TG12.1 – Civil/Sitework at Grade/Ground Level Landscaping

Questions are numbered in the order received. Numbers missing in the sequence either have been answered in a previous response set or will be answered in a future set.

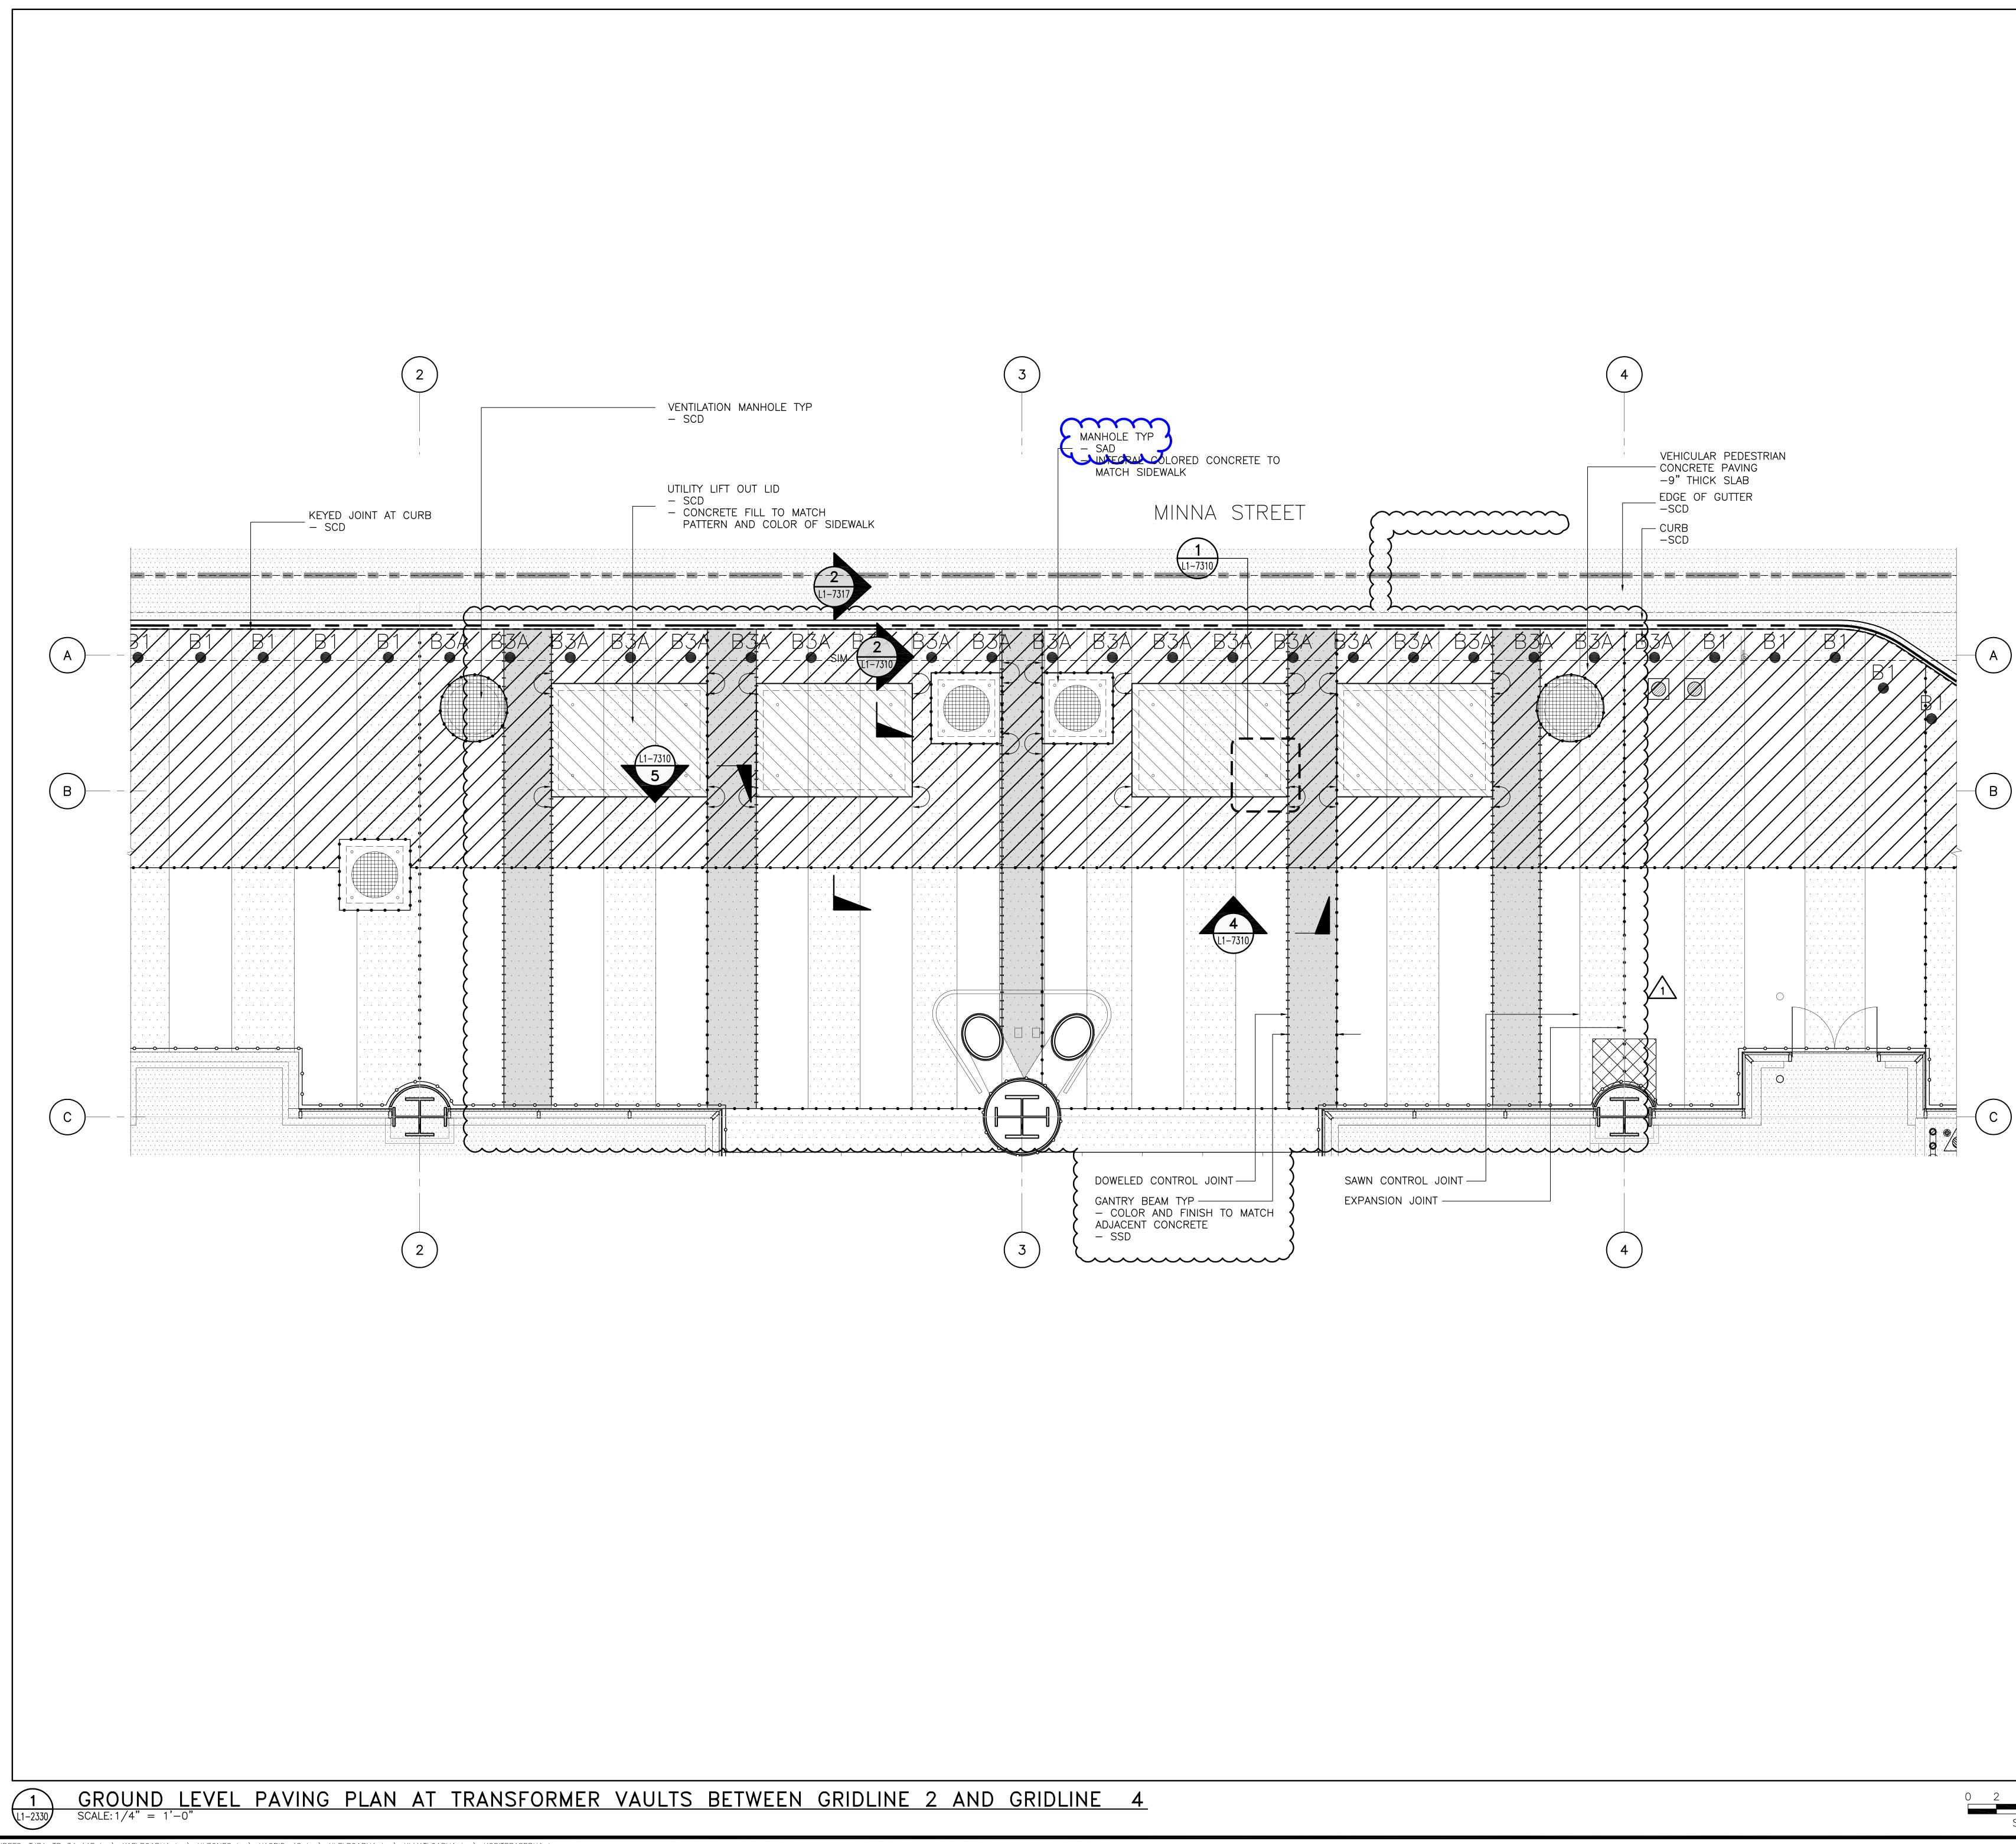
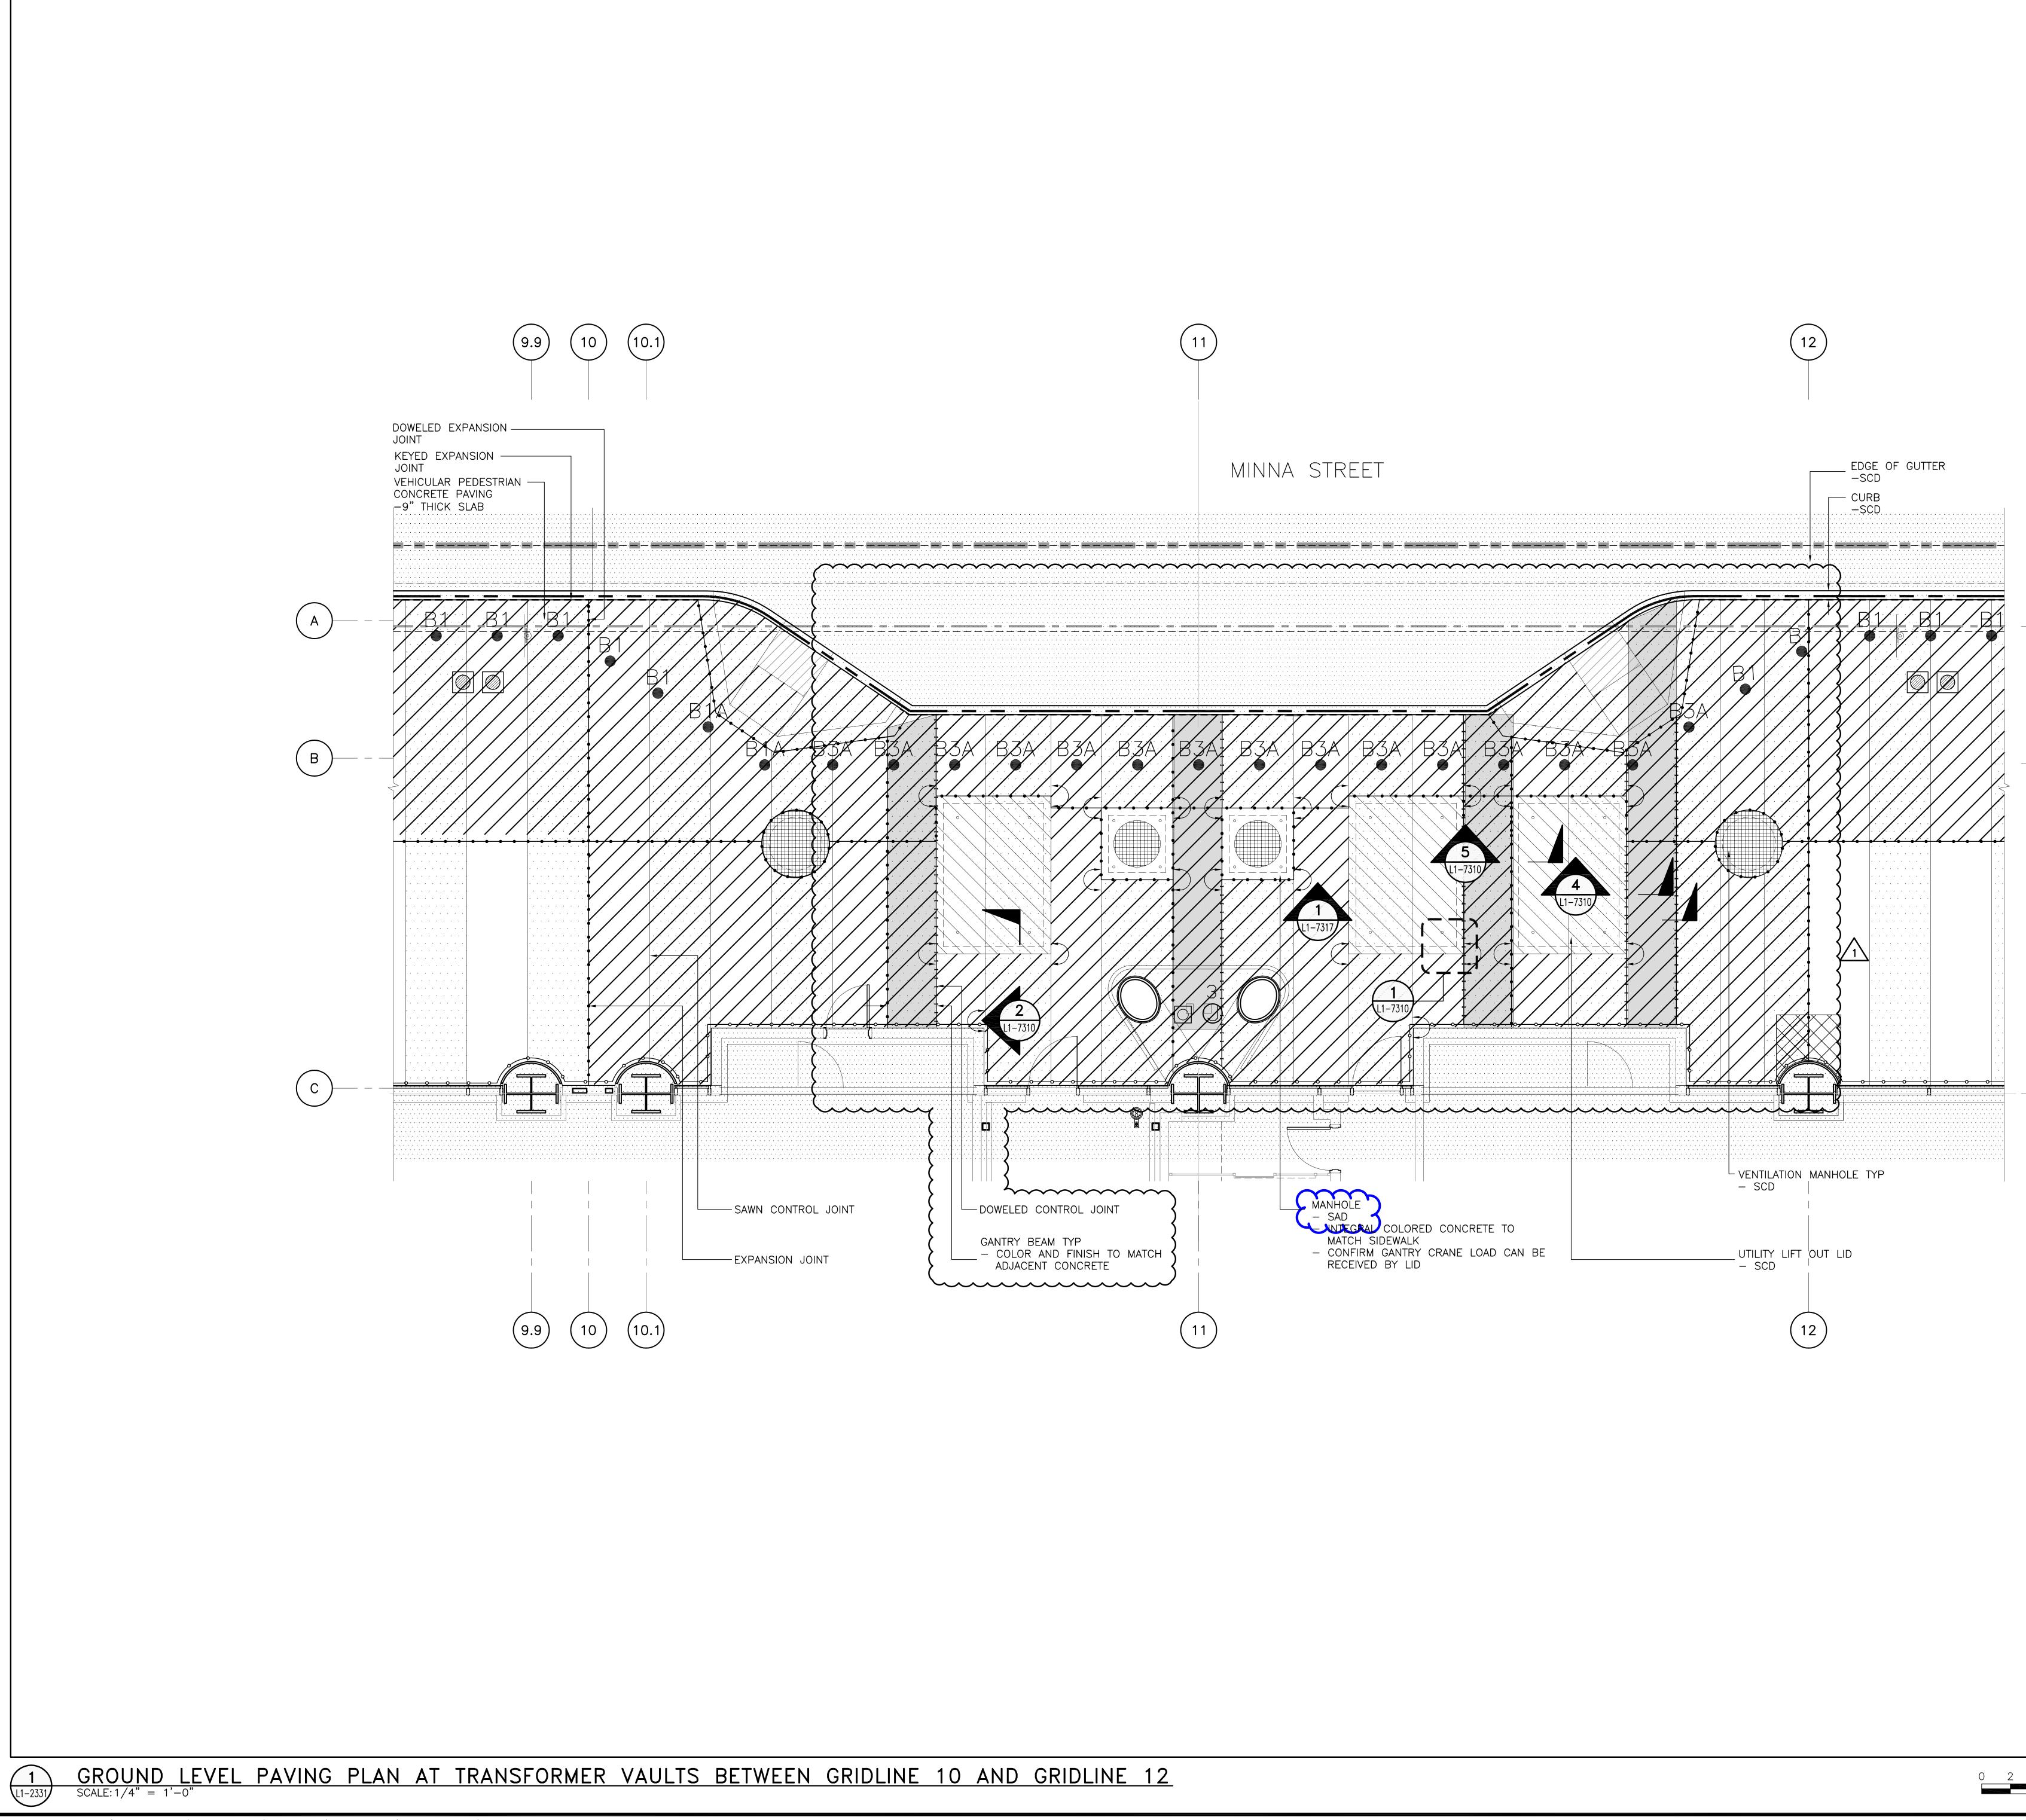
TG12.1- 025	5/18/2015			The columns/shafts for the temporary bridges to be removed are nominally 48" diameter, but due to required construction methods (drilled shaft) they are typically larger. What is the maximum diameter of the columns to be removed? Will the TG12.1 Trade Subcontractor be required to perform any chipping to allow removal of these columns, as detailed in the Temporary Bridges Removal Narrative? If so, how much?	CIDH drilled piers vary in diameter as they were installed without sleeves; chipping will be necessary if the TG12.1 Trade Subcontractor chooses to cut and remove through the blockout. A jobsite visit is strongly recommended to assess the extent of the chipping as each of the CIDH piers vary in size. See attached submittals for reference.
TG12.1- 026	5/18/2015	L1-2330 - L1- 2332, L1-2302 - L1- 2304		Plan Sheets L1-2330 through L1-2332 show ventilation manholes and ventilation grates within lift out lids, with notes to "SCD" (See Civil Drawings). No details are provided in the Civil or Landscape Drawings. Similarly, there are "Fuel Intakes" (per Legend) shown on Plan Sheets L1-2302 & L1-2304 with the note "SED" (see Electrical Drawings). No details were found. Please provide details for all three of these features as they relate to the work of TG12.1.	The reference notes in drawings have been amended to state "SAD." Refer to architectural details 9/A1-8717 and 1 & 4/A1- 9239 for these elements. See attached sketches SKLA-432.1 through SKLA-432.4 for clarification.
